SUBJECT: CLOSURE OF NATIONAL FIRE PROTECTION ASSOCIATION
805 FREQUENTLY ASKED QUESTION 08-0046 INCIPIENT
FIRE DETECTION SYSTEMS

FAQ 08-0046: Incipient Fire Detection Systems

Guidance for Modeling Non-Suppression Probability When an Incipient Fire Detection System is Installed to Monitor Electrical Cabinets

NRC Interim Staff Position:

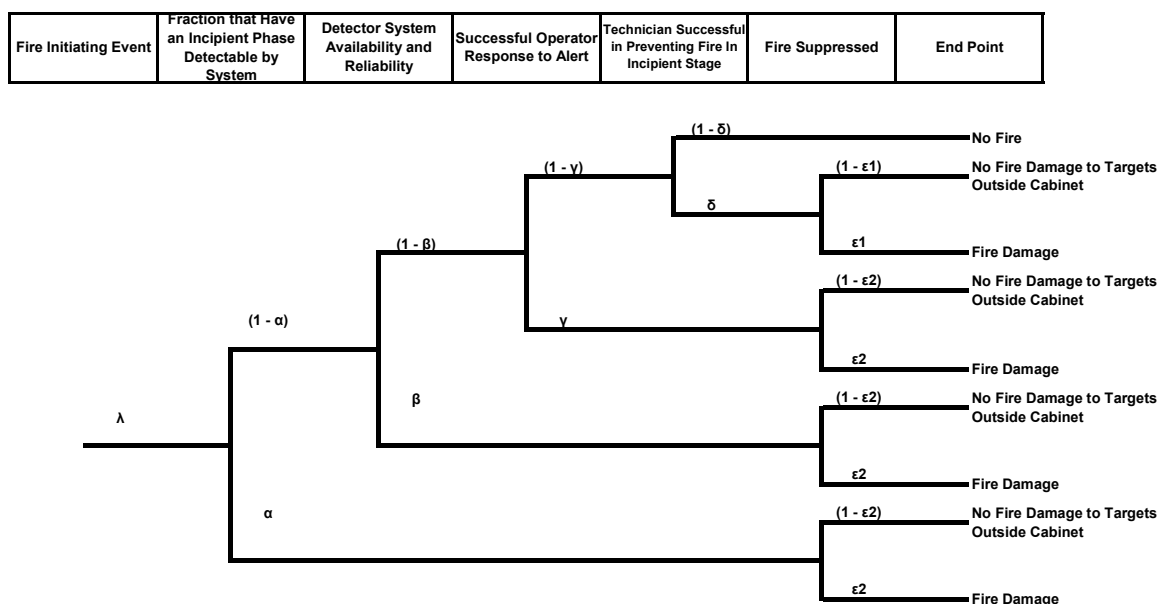
The NRC staff has reviewed the EPRI approach and the NRC interim staff position represents changes to that approach.

While the approach proposed by EPRI in 1016735 provides a high level approach to modeling a VEWFDS, there are several other issues that should be addressed and conditions applied to improve accuracy/realism.

The first relates to the population of components that would exhibit incipient degradation. An additional factor should be added to the event tree to address the fact that a given electrical cabinet may have some percentage of components that may fail quickly and therefore not allow credit for incipient detection. Examples include electrical/electronic circuit boards that contain electrolytic capacitors, chart recorder drives, cooling fan motors, mechanical timers driven by electric motors, etc.

The second relates to the rate of component degradation. The failure mechanisms that provide indication in the incipient phase may occur over extended time periods. This time period has a direct correlation to the effectiveness of the process since a longer degradation time would imply that the time period between detection of the degrading condition and a transition to a flaming fire would be longer, resulting in a higher probability of success that a fire will be prevented or, if not prevented, mitigated. However, although there is significant operating experience with VEWFDS, there is limited useful data documenting the duration of the incipient degradation time. As a result of the limited data, there is uncertainty related to the incipient degradation time. This uncertainty should be factored into the assessment of VEWFDS effectiveness.

The third relates to the response to a VEWFDS alert/alarm. Since the proposed approach uses human intervention as the primary means of mitigating an impending fire, a factor should be inserted that allows this important part of the process to be accurately modeled. In order to prevent a fire, the response activity must also include actions to remove power from the failing component/subcomponent. As the event tree is currently constructed in the EPRI report, the actions to respond to the location and find the component/subcomponent have been addressed (essentially the "Operator Response"). The skill set needed to accomplish this is similar to that for responding to any other fire: the skill set corresponding to that of an operator or trained fire brigade member. However, once the component/subcomponent has been located and identified, another skill set will be required. This task (call it the "Technician Response") requires someone knowledgeable in electrical/electronic circuits that can locate and read the appropriate drawings to determine how to remove power from the degrading device. In many cases, this activity is not a trivial exercise. It may involve researching numerous drawings (elementary, connection, interconnection, etc.) to properly locate the appropriate fuse, circuit breaker or switch. In some cases, the required isolation device may not be in the same cabinet, row, or possibly even in the same room.

Based on these considerations the following event tree is proposed for more accurately assessing the risk of fire assuming that a VEWFDs is installed. There is limited data from which the various factors can be derived. The EPRI report has cited a small number of tests that demonstrate the sensitivity of VEWFDs. The tests, however, do not address the duration or probability of the incipient degradation process that is a key factor in the true benefit of these systems. The NRC approach to dealing with this lack of data is addressed in the following.

At this time, this interim staff position, and the corresponding event tree, only applies to the installation of VEWFS installed to monitor incipient fire conditions inside low voltage (less than or equal to 250V) electrical cabinets. The branch points of the event tree are discussed in turn below. Each branch includes conditions that should be in place to obtain the credit listed.

Fire Initiating Event	Detector System Availability and Reliability	Successful Operator Response to Alert	Fire Suppressed	End Point
-----------------------	--	---------------------------------------	-----------------	-----------

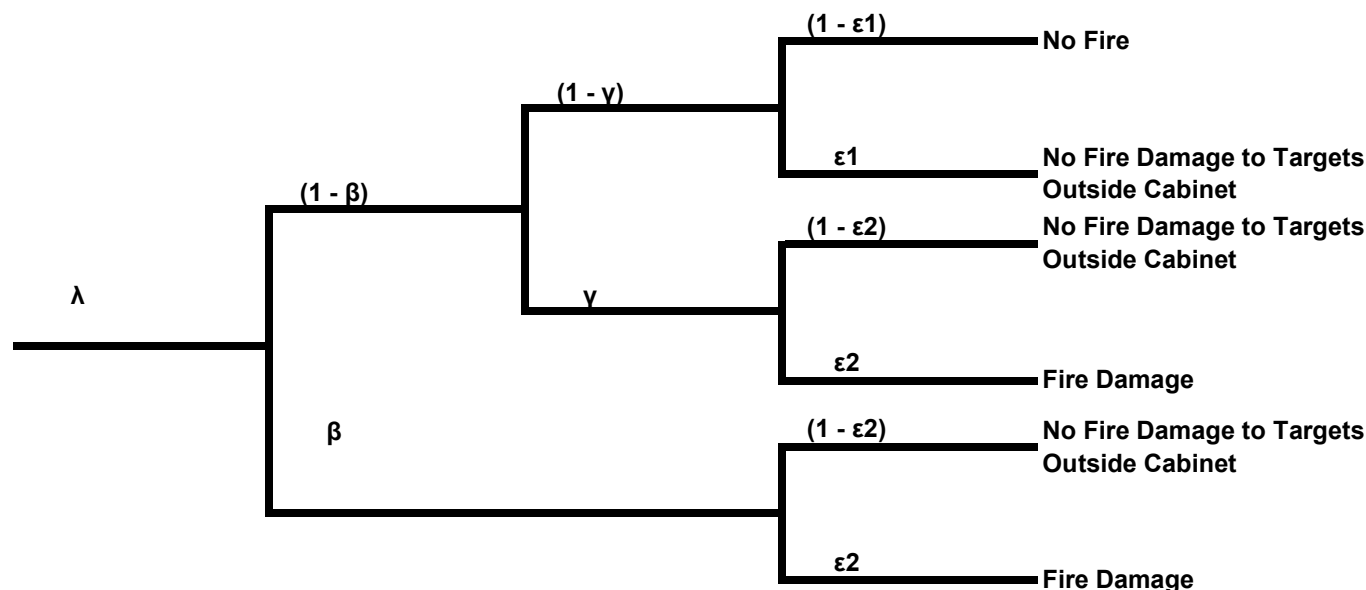
With the above simplifications, the event tree simplifies to the following:
